SHEPHERDS HILL AMENDMENT

STAFF REPORT #2

November 30, 2022

Residential Site Plan / Shepherds Hill, Map 177 Lot 5, Shadowbrook Drive, Hudson, New Hampshire, Hillsborough County; prepared by: Keach-Nordstrom Associates, Inc. 10 Commerce Park North, Suite 3B, Bedford, NH 03110; prepared for: Shepherd's Hill Home Owners Association C/O Great North Property Management, 3 Holland Way, Suite 201, Exeter, NH 03833; consisting of 54 sheets including a cover sheet and general notes 1-17 on Sheet 1; dated May 2, 2022; last revised October 6, 2022.

DATE: MAY 2, 2022 SCALE: 1"=30'
 PROJECT NO: 17-0824-1 SHEET 16 OF 51

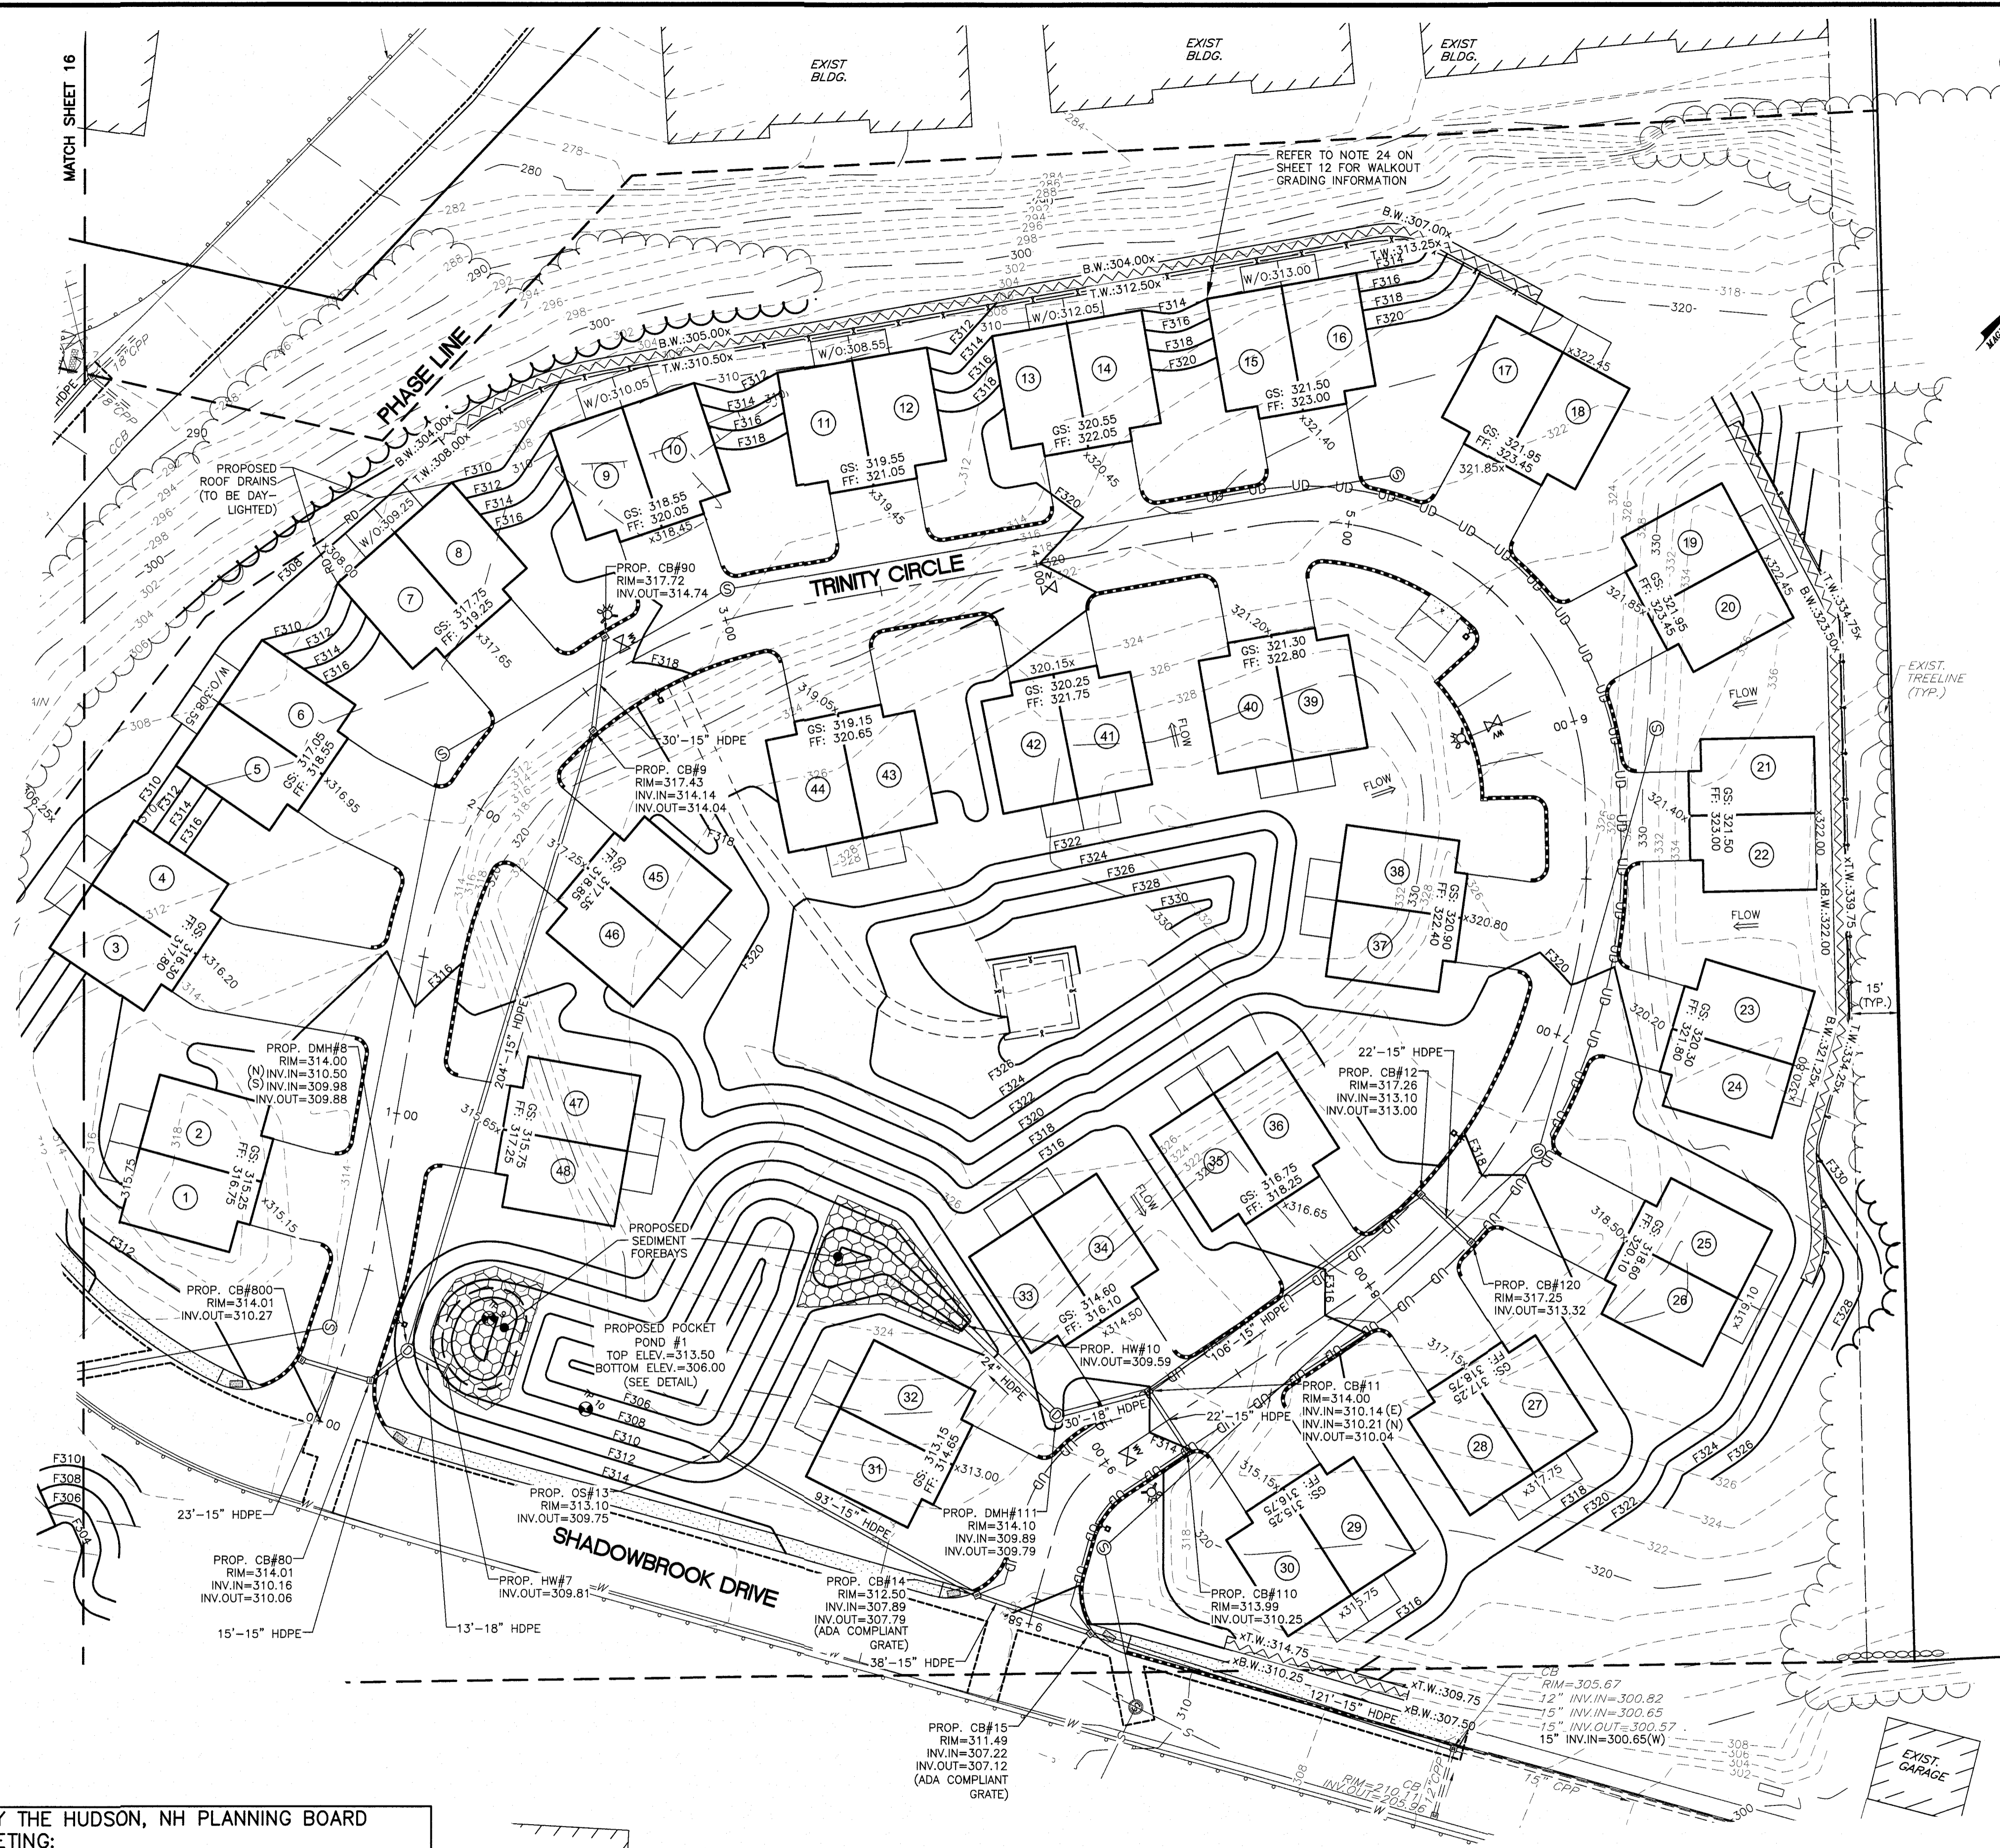
Gifford Circle (sheet 16). The grades appear to create puddling at the building garage doors.

The parking area has been revised to be 5%, refer to Grading & Drainage Plan sheet #16 and profile on sheet#36.

DATE: MAY 2, 2022 SCALE: 1"=30'
 PROJECT NO: 17-0824-1 SHEET 22 OF 51

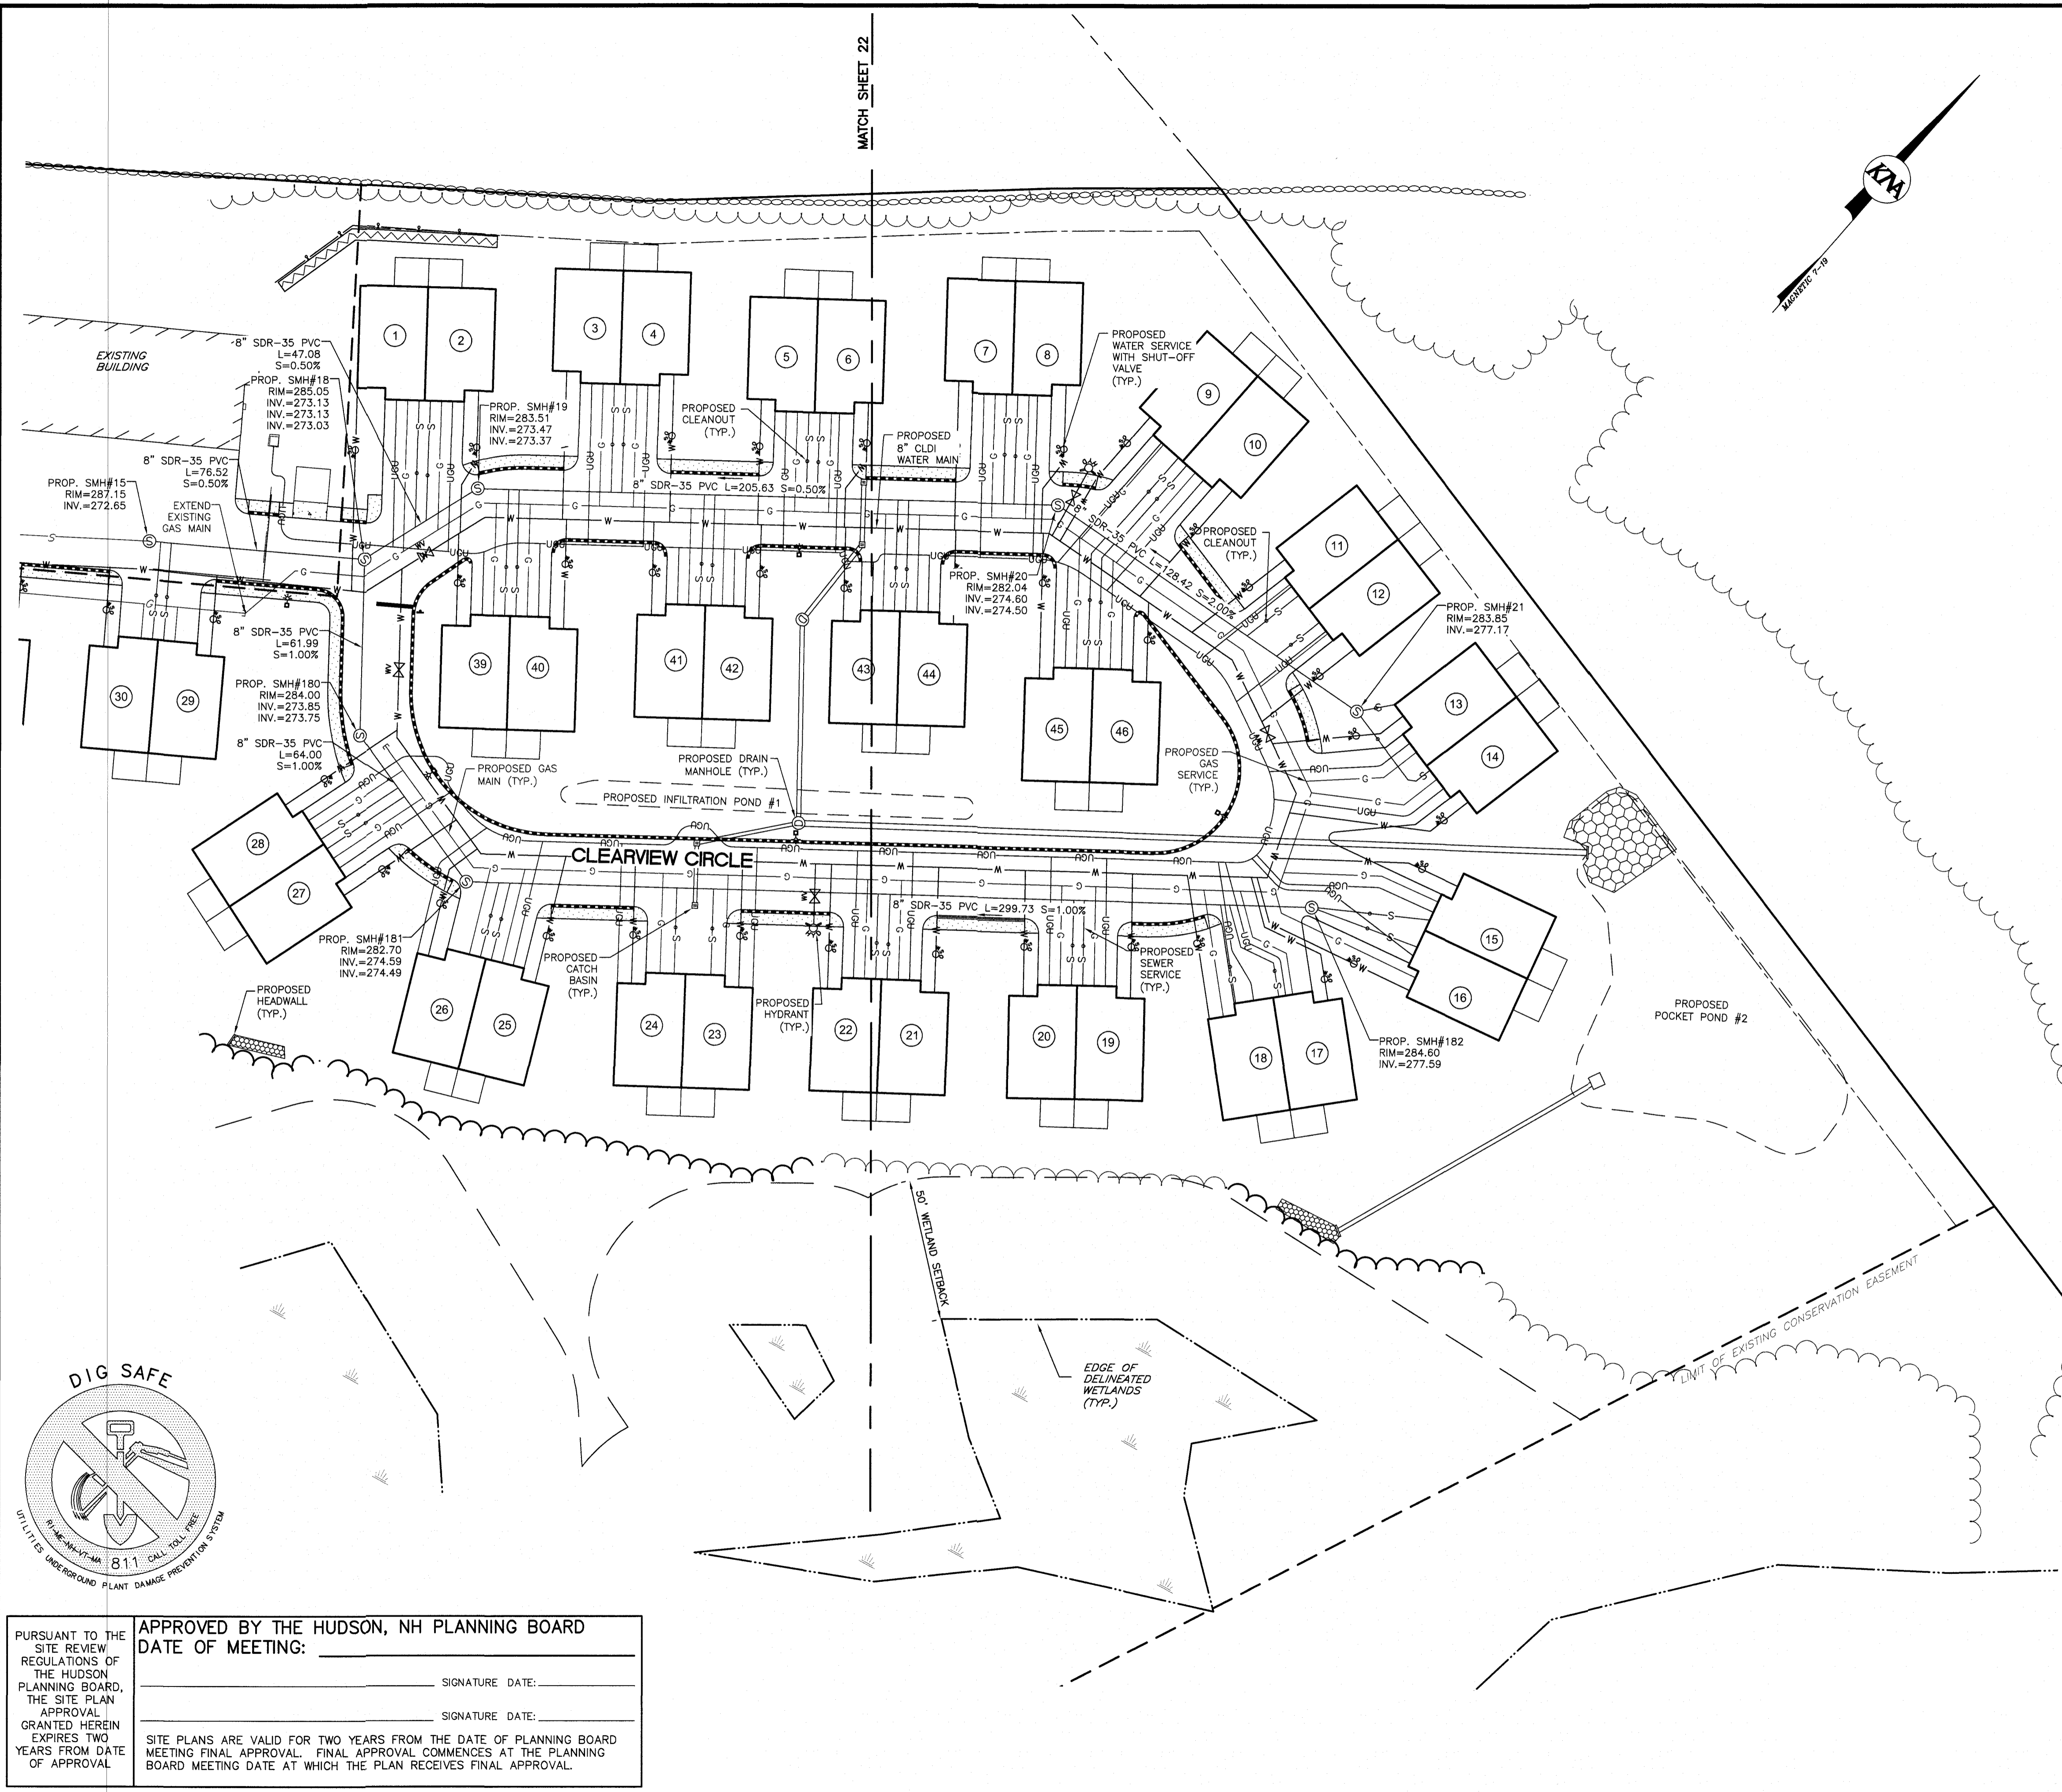
Current Fuss & O'Neill Comment: The applicant has revised the proposed water main location on the plan set. A connection to the existing hydrant should be shown, and the "Extend Existing Water Main" note on sheet 22 should be removed from the plan.

h. Former Fuss & O'Neill Comment: The proposed sewer connection into SMH #15 appears to be less than 10 feet from the existing Clearview Circle water main. We note that the plans show the existing Clearview Circle water and sewer mains less than 10 feet apart between units 36 and 30. Current Fuss & O'Neill Comment: The applicant has revised the proposed water main location on the plan set. A connection to the existing hydrant should be shown, and the "Extend Existing Water Main" note on sheet 22 should be removed from the plan.

The connection to the existing hydrant is shown, refer to Utility Plans sheet #22. The note on sheet #22 has been removed as requested.
